## Re: Agnico Eagle's response to Meadowbank Gold Project 2016 Annual Report and Recommendations

As requested, the following information and comments are intended to address the recommendations outlined in response to the NIRB recommendations and comments in the letter dated July 6, 2017, Opportunity to Address Comments Received Regarding Agnico Eagle Mine Ltd.'s "Meadowbank Gold Project" 2016 Annual Report.

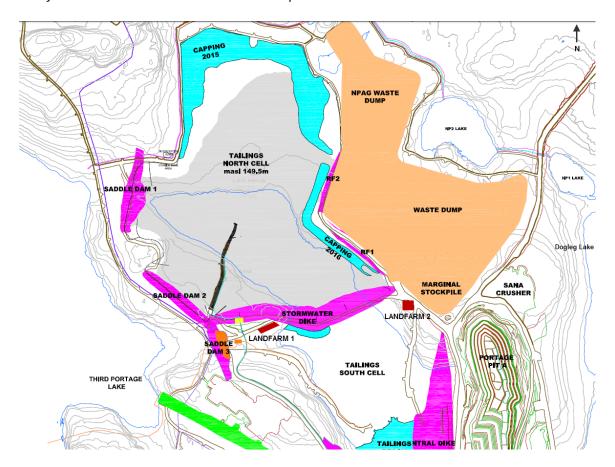
Concern: AEM decided to find a new location for the landfarm (Landfarm 2) to continue treatment of contaminated soil, since the existing landfarm (Landfarm 1) is located on the northwest side of the South Tailings Cell, which is predicted to be flooded with reclaim water in the summer of 2017. Landfarm 2 was constructed in 2016. An extension of Landfarm 1 was also built at a higher elevation in 2016 to continue treatment of soil at this location. AEM does not indicate where Landfarm 2 is located, norwhen it will begin operation. Similarly, it is not clear when Landfarm 1 will cease operation, and how the remaining soil there will be managed to

**Recommendation 22:** Please indicate the location of Landfarm 2 and explain when it will begin operation in the Annual Report.

Landfarm 2 is located on the north east side of the South Tailing Cell, north of the Central Dike. Please find on figure below the location of the Landfarm 1 and Landfarm 2. The as-built report has been sent to NWB on November 18, 2016 (Appendix J1 2016 Annual Report). Disposal of contaminated soil in Landfarm 2 have started in January 2017. The completion of the Landfarm 1 and the details of the first year of operation of the Landfarm 2 will be discussed in the Annual Report 2017.

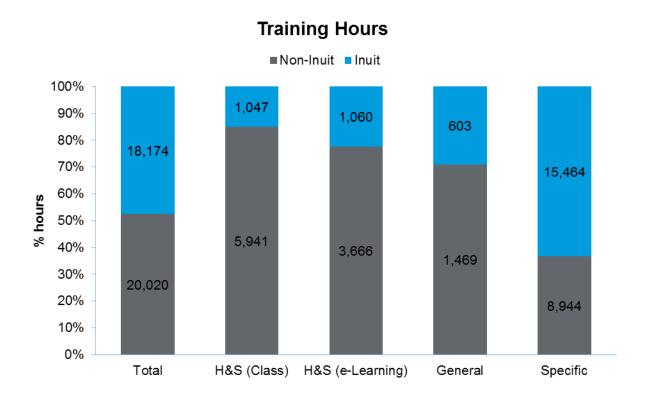
**Concern:** It is very difficult to read Figure 41 because the white portion of the bar graphs blends in with the white background.

**Recommendation 38:** Please change the colour scheme in Figure 41 to provide more contrast between the bar graphs and background.

Please find below Figure 41 corrected to facilitate the reading. Agnico acknowledge KIA comments and will make sure for the following Annual Report to use colour that will contrast.
